**New York State Department of Environmental Conservation
Division of Environmental Permits, Region 4**

Re: DEC #4-0124-00001/00057
SPDES # NY-0005037
FACILITY: LaFarge Ravena Plant
Town of Coeymans, Albany County

Response to comments:

Response to USEPA comments:

Figure 1 Map Showing All Outfall Locations
SPDES Permit NY-000-5037

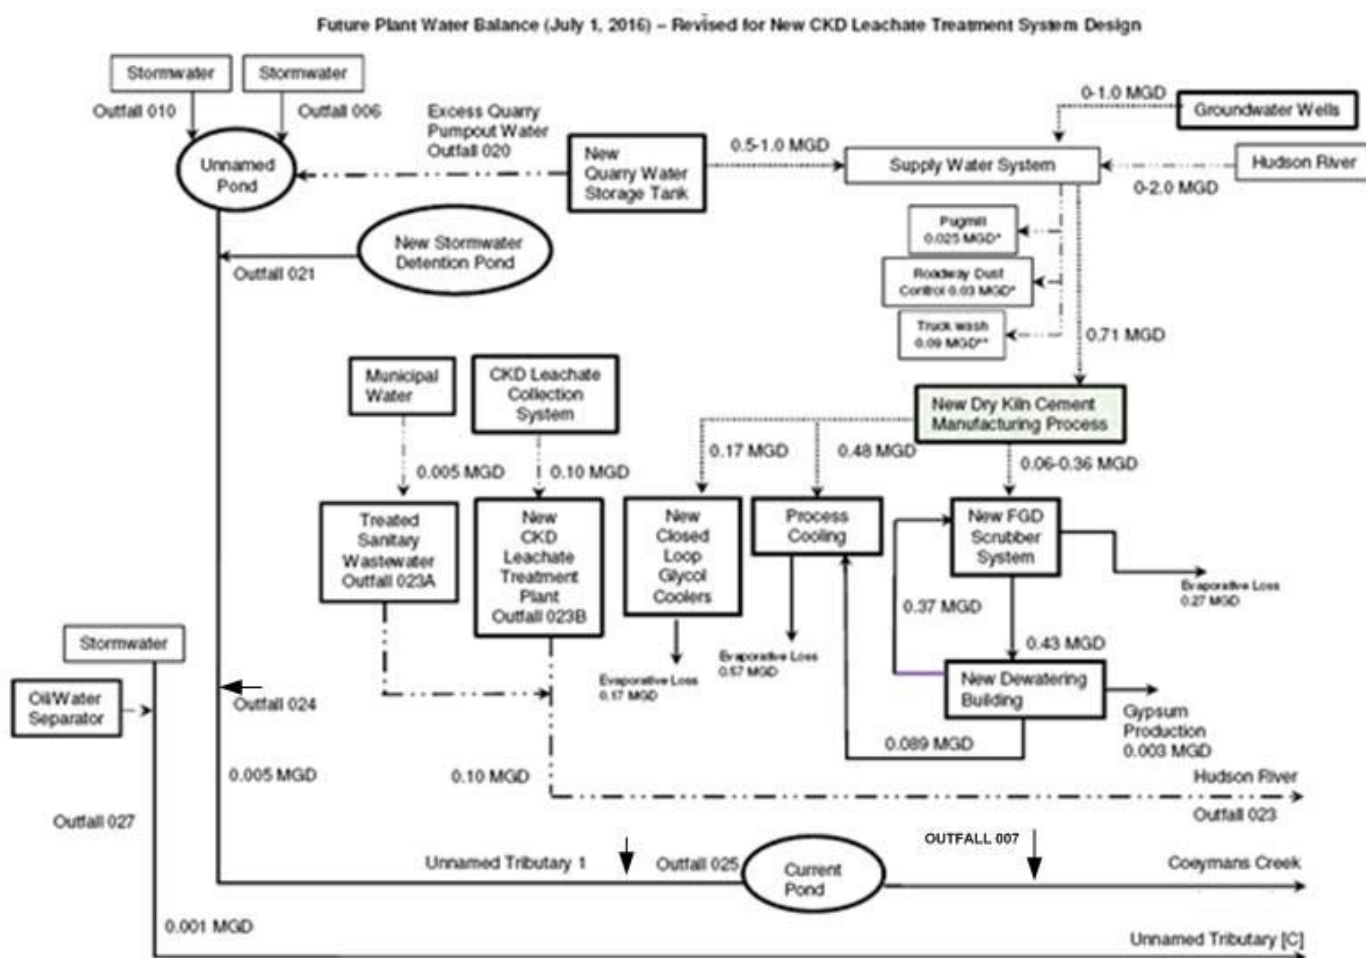
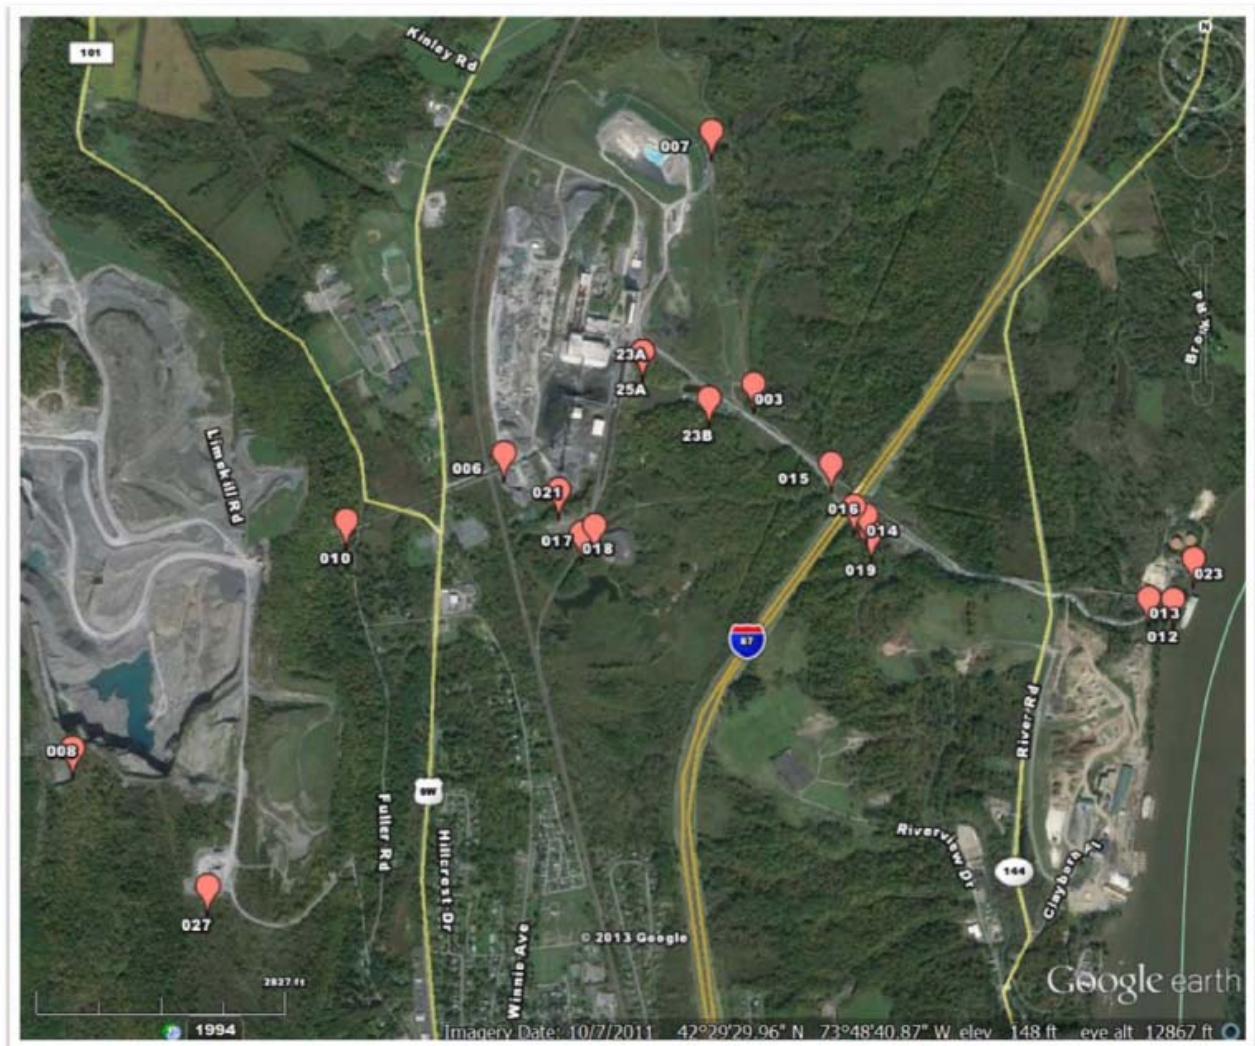
On page 23 of 27 the figure does not have "text" identifying Outfall 003 (generally found below the arrow and line identifying Coeymans Creek) which will become Outfall 028 upon RPM startup. The note mentions Outfall 003 changing to all stormwater and excess quarry water (from Outfall 020) but again it does not indicate its new outfall designation (028).

The diagram of the treatment process on page 23 of the draft Lafarge permit is blurry and illegible. The map on page 24 of the draft Lafarge permit is too dark to be useful for identifying the additional outfalls. Please provide a diagram for the plant after modernization that clearly identifies the monitoring locations for all outfalls in the Lafarge permit and a legible map of the additional outfall locations.

The department prefers to retain the outfall number (i.e 003) and therefore page 23 will not change.

Pages 23 and 24 are revised with best available diagrams.

On page 24 of 27 the note should be revised to include Outfall 021 not Outfall 020 as follows - "Outfalls 021, 024 and 025 become active in July 2016". The reference to "Outfall 020" should be deleted.
